12. 19-0998 Latrobe Railroad Storm Damage Repairs Project

HENNINGSEN LOTUS PARK &
LATROBE RAILROAD
STORM DAMAGE REPAIRS

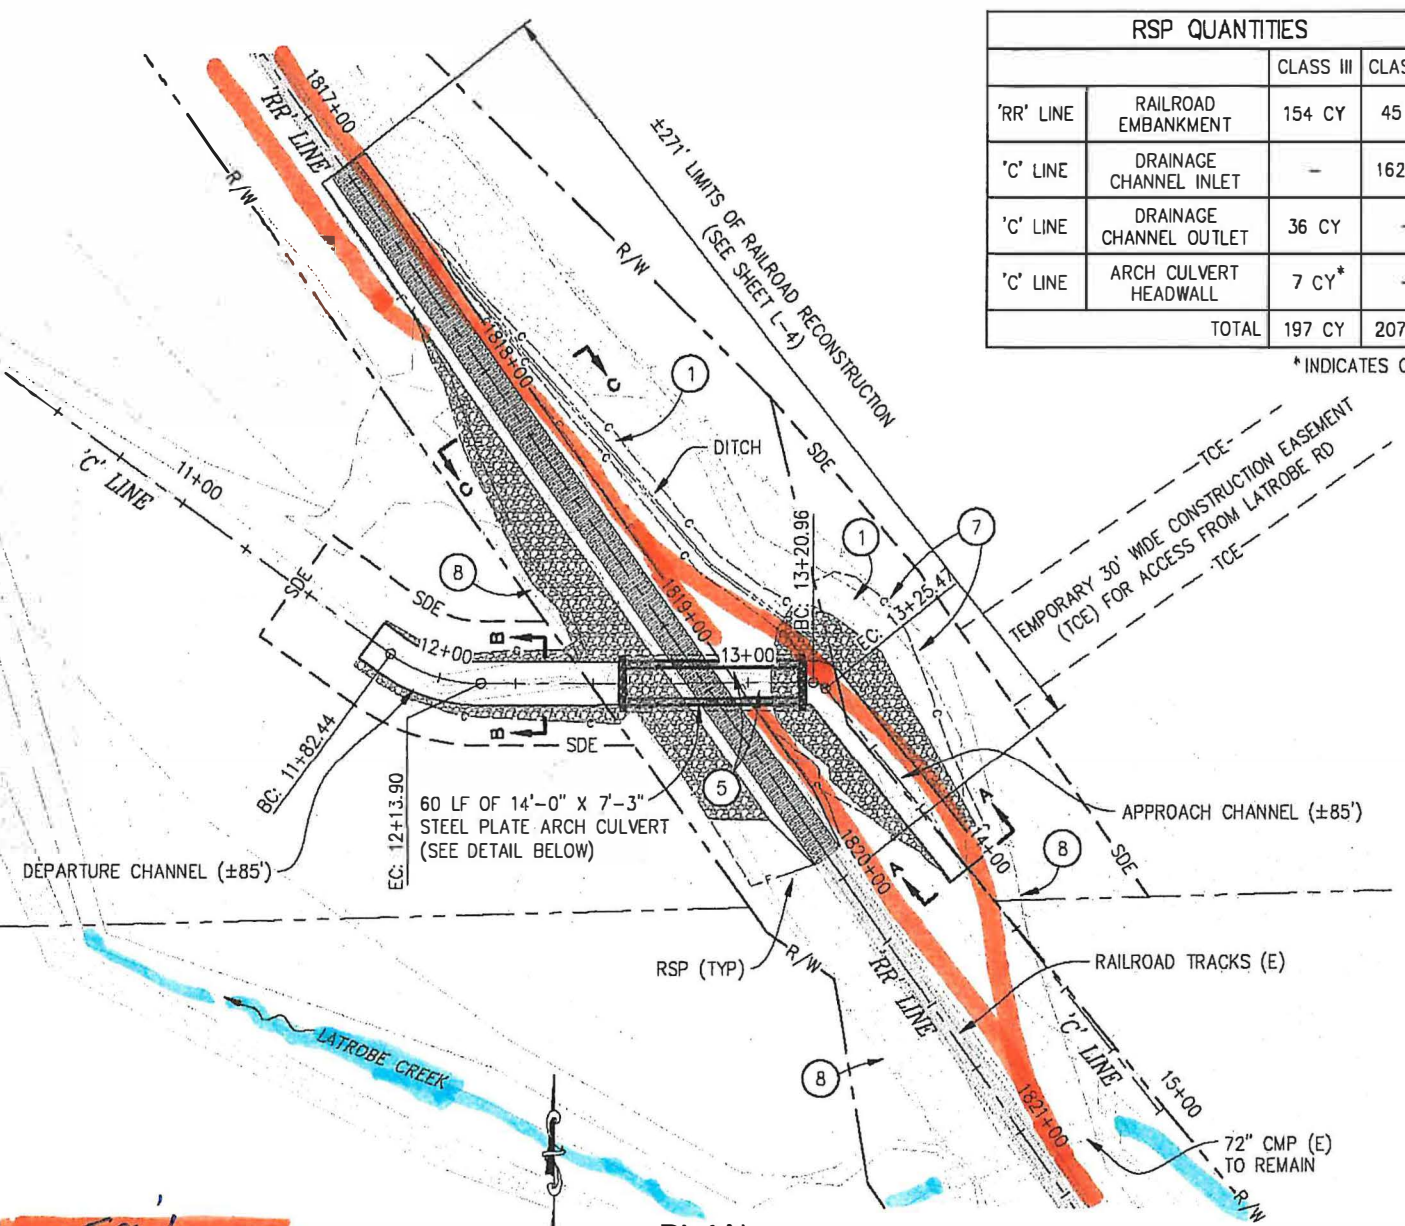
On the maps page, it indicates 1. ballast to be added outside the washout area. This ballast has been gone for a decade, and was not part of the recent damage. Why is it being included in this project? Why are FEMA funds and taxpayer funds being used to restore an structure only used for excursion train use outside the project area?

Will FEMA and taxpayer funds also be used to install railroad ties and rails on this transportation corridor where the only federally recognized planned transportation use is a class 1 bike path?
